Re: Public Comment Overview - File No. 2207-019 / 6950 SE Maker Street / Parcel
No. 9350900620

Gross Floor Area (GFA) - (MICC 19.02.020 Development Standards / Appendix B - Basement Floor Area Calculation)

Designated Existing Grade - (MICC 19.02.020 Development Standards / 19.16 Definitions / Administrative Interpretation (AI) #04-04 / Administrative Interpretation (AI) #DCI12-04)

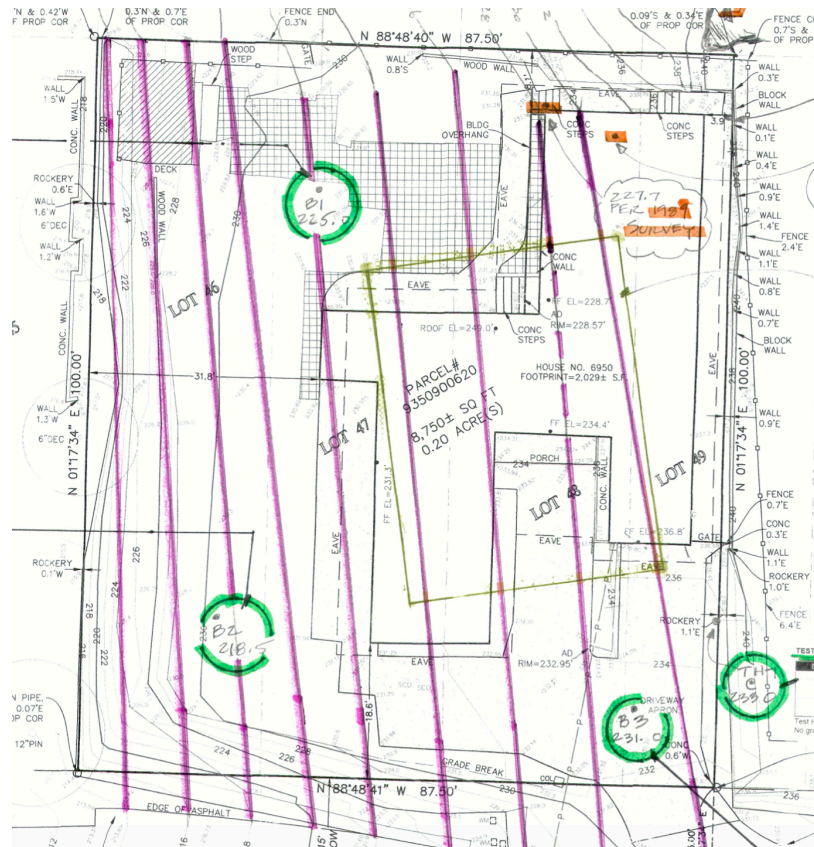
Lastly, the contours from the survey can be straight line interpolated with the contours of Maker Street. Maker likely received very little grading and filling along this stretch because of its steep course westward. Its contours lie mostly perpendicular to the fall line indicating that the road follows the steep slope downward with very little alteration. (In fact, this was corroborated by comparing a 60 year-old topographical map of First Hill and a not yet paved Maker Street with the current Lidar imaging available on the City’s GIS mapping portal.)

From this simple interpolation, the original topography of the 6950 site really takes shape, and again, is what you might expect both on paper and if you were out on site. Yes, the linear contours (highlighted in pink) lack the natural meander one would get had several shots been taken for each contour. But by the same token, all three parcels are laterally aligned with respect to the steep slope orientation and the contours line up in way that is expected. The adjusted existing grade for the borings and test holes are markedly in the ballpark on the 6950 site. And the basement floor spot elevation is within a foot of the floor elevation taken in the 2021 survey.

Photo 2 and Photo 3 from Stormwater Drainage report below. Note: Due to elevations and slope, No stormwater run-off is able to reach either culvert.

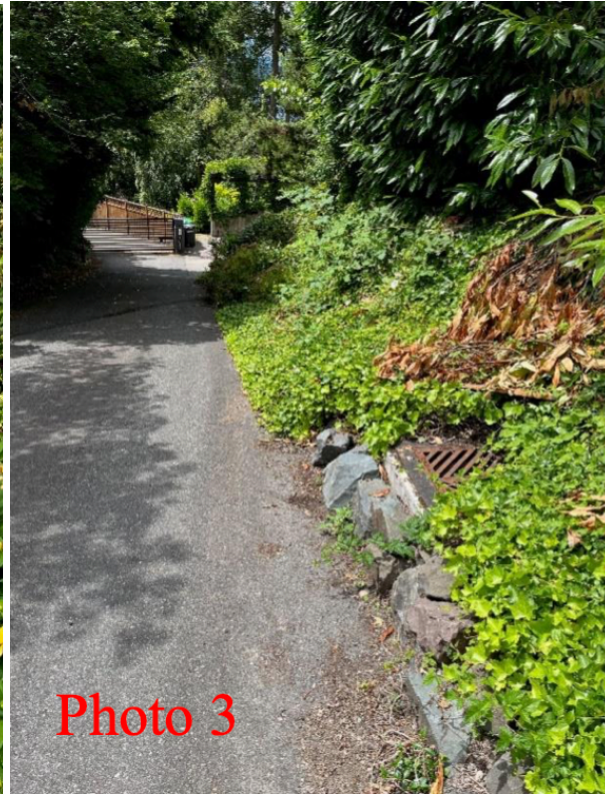
The challenge for the subject property, 6950 SE Maker Street, is that **neither** catch basin in Photo 2 and Photo 3, catch runoff from the subject property or the street, SE Maker. The one

catch basin just east of the driveway (Photo 2) is at a higher elevation than the subject's driveway and SE Maker Street. It was completely grown over from nonuse and recently cleared from weeds, i.e. St. John's Wort and ivy. This culvert doesn't collect rainwater coming down Maker Street due to the location and elevation.

The catch basin in Photo 3 is elevated in the rockery. The only way for this basin to collect stormwater is if water collection was directed in pipes to this culvert/catch basin. This storm drain is located midway below the subject property but is not located at road grade.

Therefore, we believe that the subject property should be required to tightline/pipe all stormwater during construction and construction runoff into one of the unused storm drains. In that case there is less chance that the construction project stormwater would breach the existing berms/curbs and overwhelm the two functional culverts located at 7030 SE Maker Street. See photos below and Appendix.

BUILDINGS ELEVATIONS

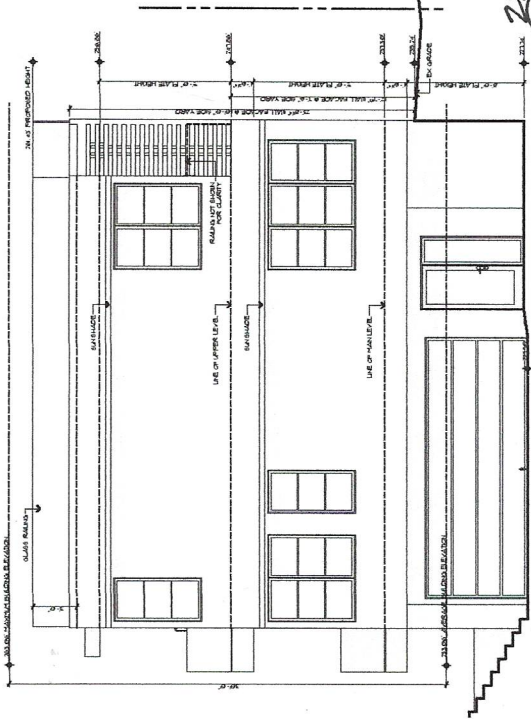
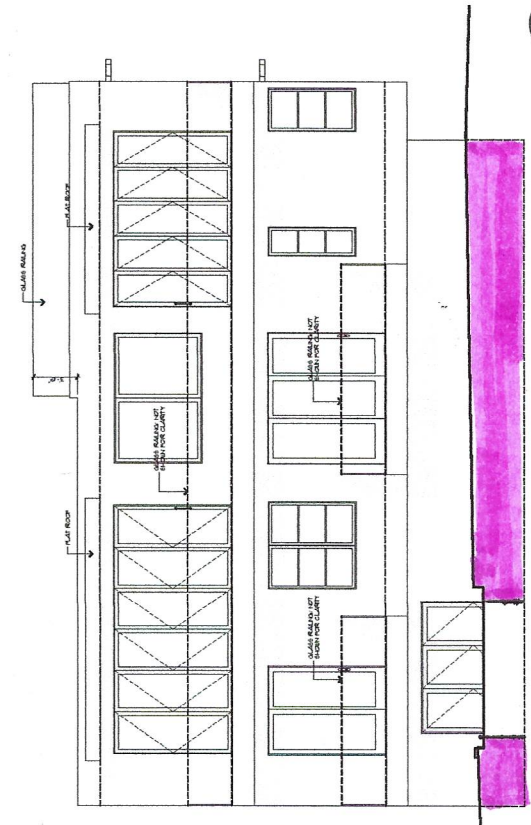
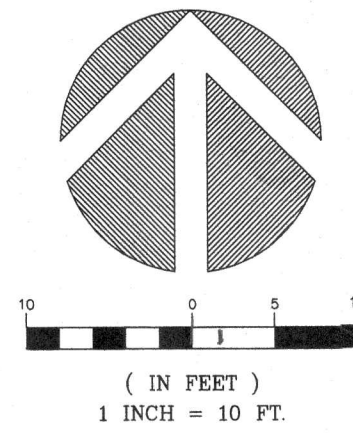
The GFA calculation for the basement/garage level of the home is incomplete and does not comply with the MICC. Furthermore, when the GFA is correctly and fully applied to all floors, it exceeds the MICC GFA coverage of 40% for R8.4 zoning, and therefore does not comply as well.

We determined that 51% or 803 sf of 1,575 sf basement/garage should be excluded from the GFA - not 100%. Our adjusted total is 3,498 + 772 basement inclusion = 4,270 sf which exceeds the 40% threshold.

Though the existing grade elevations were not shown on the three of the elevation drawings, existing elevations were used from the survey drawing to gain approximate grades. And where "proposed finished grades" were lower, as per Appendix B - Basement Floor Area Calculation, we used those at the garage front and entry and the basement patio door. A copy of our calculations are included in the attachments.

3
 1575 \$ FOR SAKE OF BREVITY -
 X.51 100% OF BSMT WALL COVERED
 803 \$ MAY BE EXCLUDED

4
 55% COVERED
 81.5
 35 + 45 + 45 + 35 = 51% COVERAGE

TOPOGRAPHIC & BOUNDARY SURVEY
 PARCEL NO. 9350900620
 STRAND RESIDENCE
 6950 SE MAKER STREET
 MERCER ISLAND, WA 98040

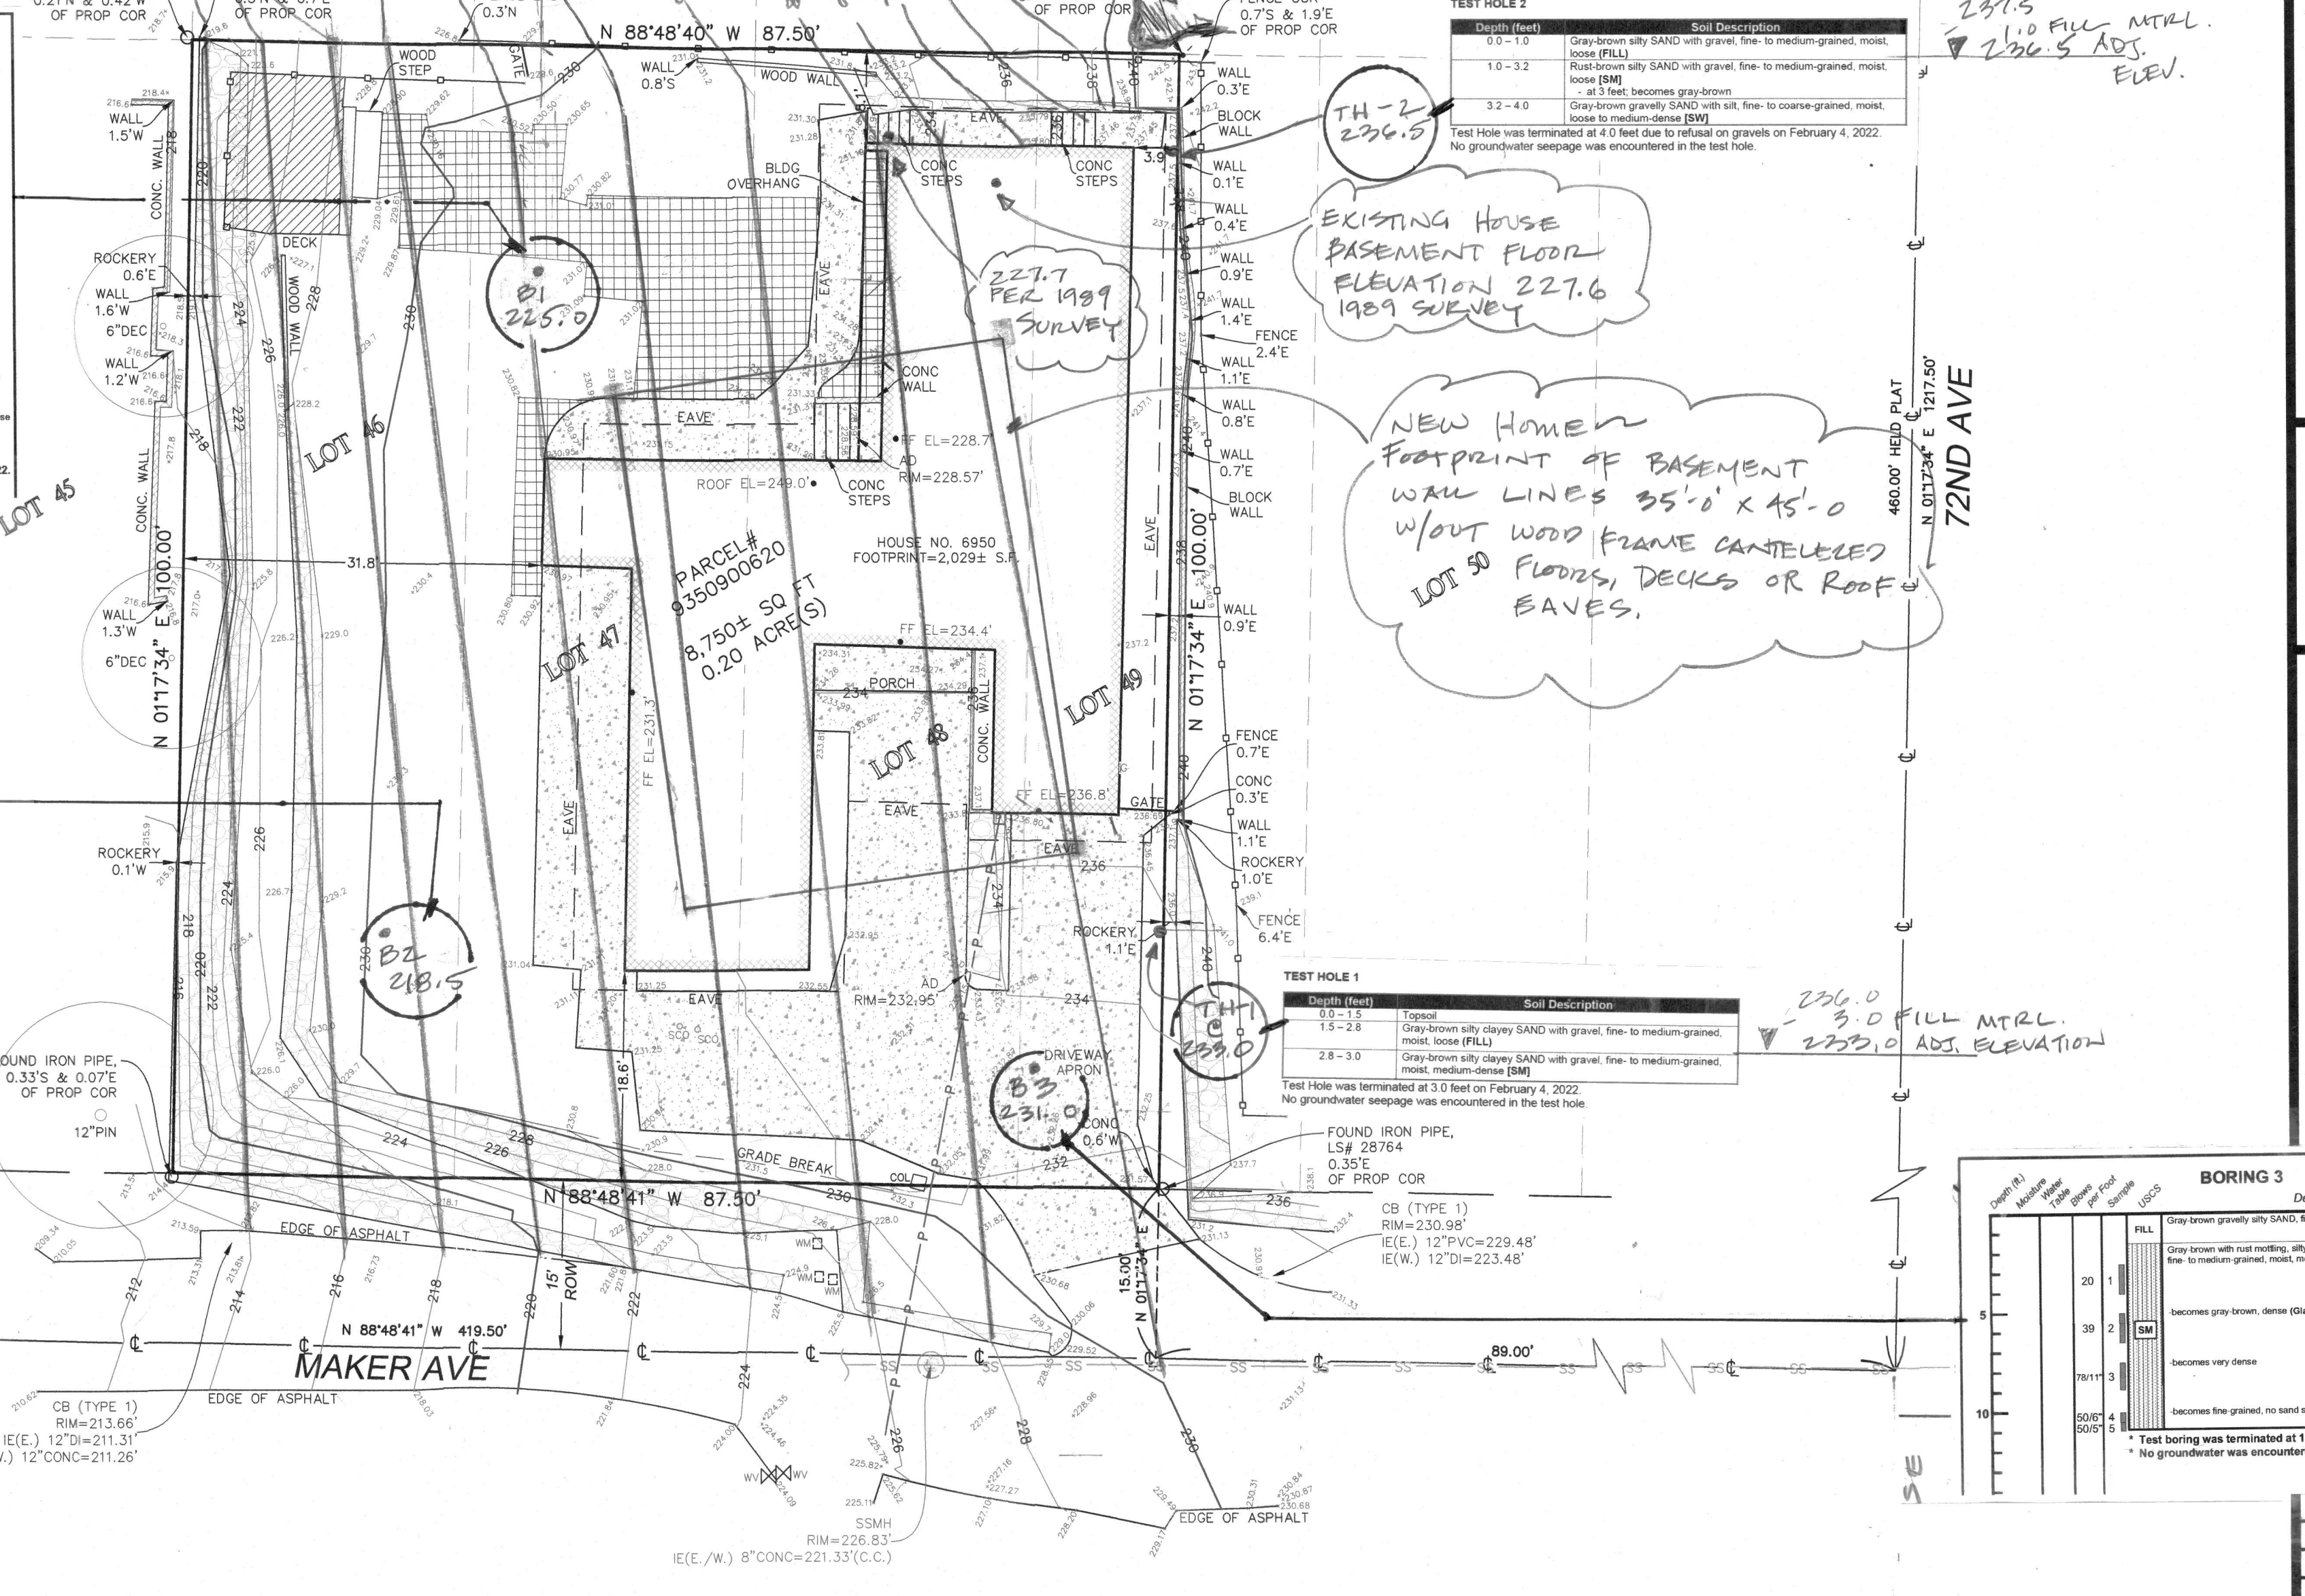
(Please note, we do not agree that most of the spot elevations and contours shown on Terrane sheet 1 of 1 meet the MICC definition of existing grade, however we did use them to illustrate our points above.)

A majority of the spot elevations and contours on the survey plan, Terrane sheet 1 of 1, which are designated by the applicant for design of the proposed project, do not meet the MICC definition of *existing grade* and more extensively, *alteration* and therefore, do not comply with the MICC.

231.0
 - 6.0 FILL MATERIAL
 = 225.0 ADJUSTED ELEVATION

230.0
 - 11.5 FILL MATERIAL
 = 218.5 ADJUSTED ELEVATION

231.0
 - 6.0 FILL MATERIAL
 - 225.0 ADJUSTED ELEVATION

230.0
 - 11.5 FILL MATERIAL
 - 218.5 ADJUSTED ELEVATION

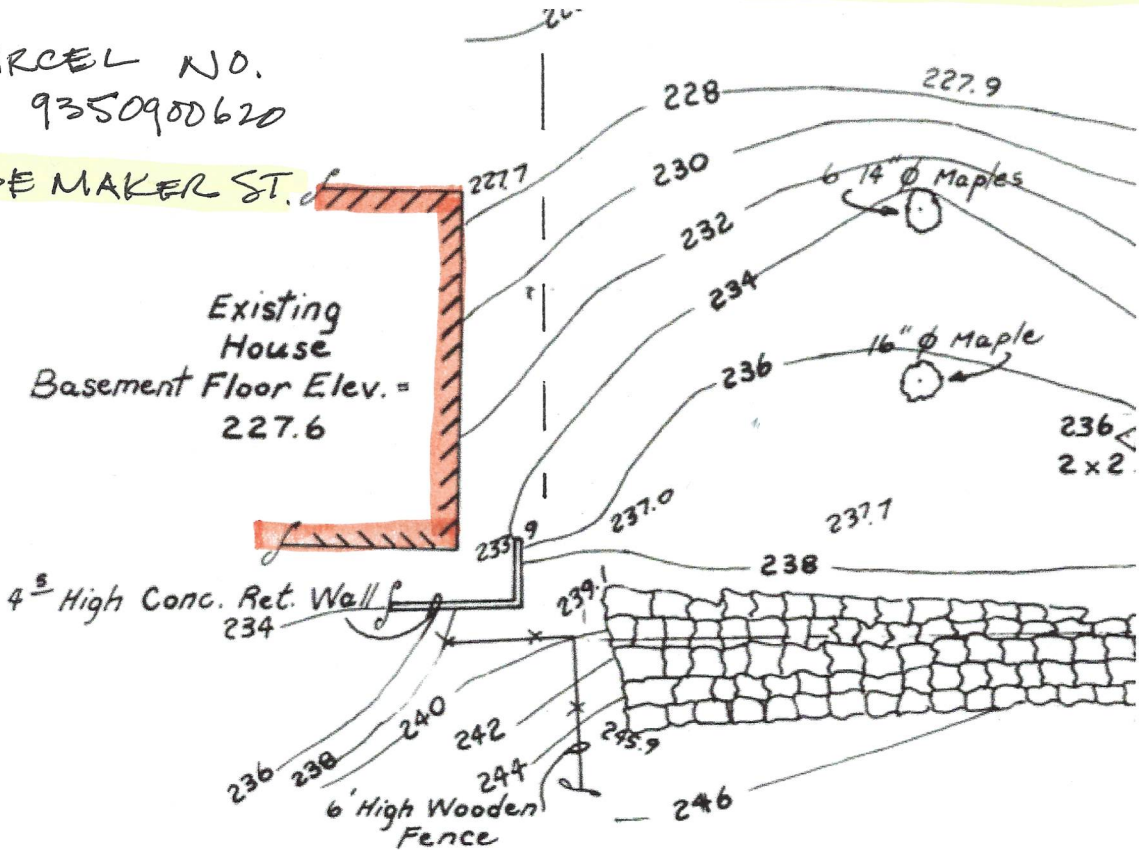
Using the City’s GIS mapping portal, we were able to locate a survey from parcel no. 9350900410 (7145 SE 35th St.) which is located directly north and adjacent to the project site. The survey is dated May 1989 and was prepared by D.R. Strong Consulting Engineers (Engineers / Planers / Surveyors), Kirkland, WA.

Third, a portion of the 6950 site was in fact surveyed. There are three contour lines that originate from the north wall of the NE portion of the existing house and included are two spot elevations, 227.7 at the exterior wall and the “existing house basement floor elevation” of 227.6. Additionally, there are three others that terminate in the vicinity of the NE property corner. The remaining contours either cross southward past the 6950 site property lines or abut the rocky wall that 90s back into the toe of the slope in the NW corner.
